SAFETY RECALL INFORMATION

Subject: Safety Recall JS
1996-1997 Model Year Audi A4
Replace Ignition Switch

Safety Recall Circular

**Subject: 1996 - 1997 Model Year Audi A4
Replace Ignition Switch**

Section B – Ignition Switch Removal and Installation

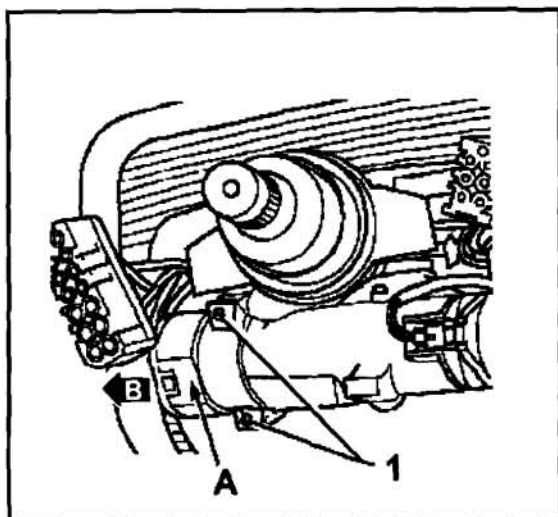
- ⇐ Remove paint seal covering screws -1-
- ⇐ Loosen two screws -1- with a small flat screwdriver, and pull ignition switch -A- out of housing in direction of -arrow B-

Tip: Ignition switch and lock cylinder must be in the same position, e.g. "Ignition off" when installing new switch; otherwise, switch will not go into housing

- Install new ignition switch (4A0 905 849 B) fully into housing and tighten screws
- Seal screws with any color of locally available paint
